April 28, 2025

BIDDING ADDENDUM 2

For work titled: Roadway Extension - Pemiscot County Port Authority

1 JOINT PLAN AND SPACING FOR CONTRACTION JOINTS
NTS

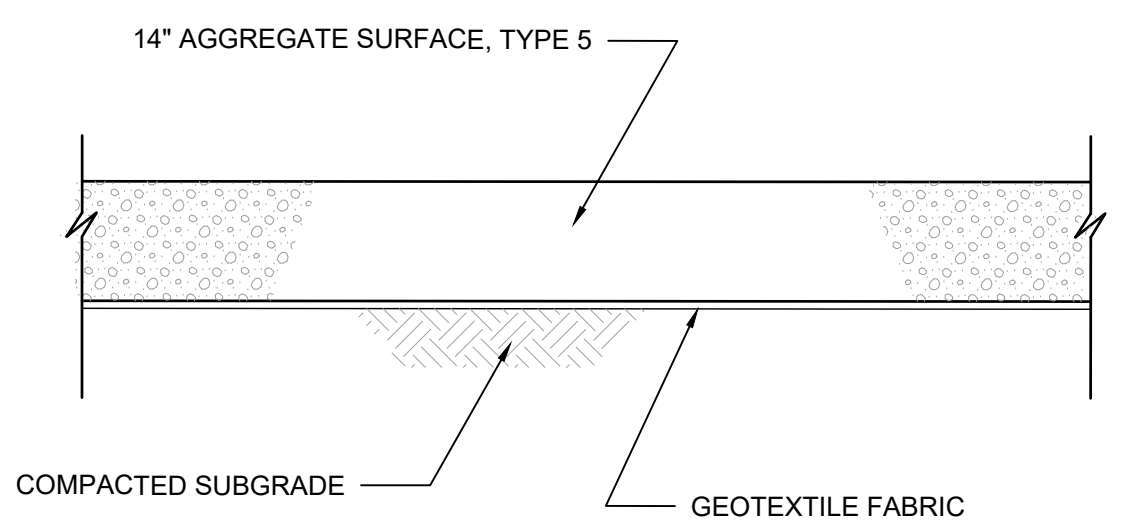
1	Questions	<p>Question: Will there be any profilographing needed?</p> <p>Response: Profilographing is not specified.</p>
2	Questions	<p>Question: I see a several notes on Sheet C003 that I am assuming do not apply to this project. i.e. Geo-grid required, etc. Can you please clarify?</p> <p>Response: Geogrid is not required. Pavement should be constructed per detail 3/C501.</p>
3	Questions	<p>Question: Sheets c101,c102 show transverse joints running all the way across roadway.</p> <p>Response: Transverse joints should extend the full width of the pavement.</p>
4	Questions	<p>Question: Sheet c501 show joints going all the way across, but only baskets on transverse joints in the travel lane sections. Is this correct? No baskets in transverse joints of shoulder area.</p> <p>Response: Transverse joints shall be per detail 7/C501, except for the first and last panels of the roadway, which should include baskets per detail 6/C501. Revise detail 1/C501 to show baskets the full width of the pavement at these joint locations.</p>

6	Questions	<p>Question: Sheet c501 it looks as if travel lanes are wider (12') than the shoulder area lanes (8').Is this correct , what are the actual widths of the lanes.</p> <p>Response: All panels shall be an equal width per detail 1/C102.</p>
7	Clarification	<p>Pemiscot County Port Authority is inviting you to a scheduled Zoom meeting.</p> <p>Topic: ROADWAY EXTENSION BID OPENING Pemiscot County Port Authority Time: May 1, 2025 10:00 AM Central Time (US and Canada) Join Zoom Meeting https://us06web.zoom.us/j/85345200326?pwd=c0ZyihBtTL3BByQS7OPaledHc7qQdl.1</p> <p>Meeting ID: 853 4520 0326 Passcode: 198933</p> <p>---</p> <p>One tap mobile +16465588656,,85345200326#,,,,*198933# US (New York) +16469313860,,85345200326#,,,,*198933# US</p> <p>---</p> <p>Dial by your location</p> <ul style="list-style-type: none"> • +1 646 558 8656 US (New York) • +1 646 931 3860 US • +1 301 715 8592 US (Washington DC) • +1 305 224 1968 US • +1 309 205 3325 US • +1 312 626 6799 US (Chicago) • +1 720 707 2699 US (Denver) • +1 253 205 0468 US • +1 253 215 8782 US (Tacoma) • +1 346 248 7799 US (Houston) • +1 360 209 5623 US • +1 386 347 5053 US • +1 507 473 4847 US • +1 564 217 2000 US • +1 669 444 9171 US • +1 689 278 1000 US • +1 719 359 4580 US <p>Meeting ID: 853 4520 0326 Passcode: 198933</p> <p>Find your local number: https://us06web.zoom.us/j/85345200326?pwd=c0ZyihBtTL3BByQS7OPaledHc7qQdl.1</p>
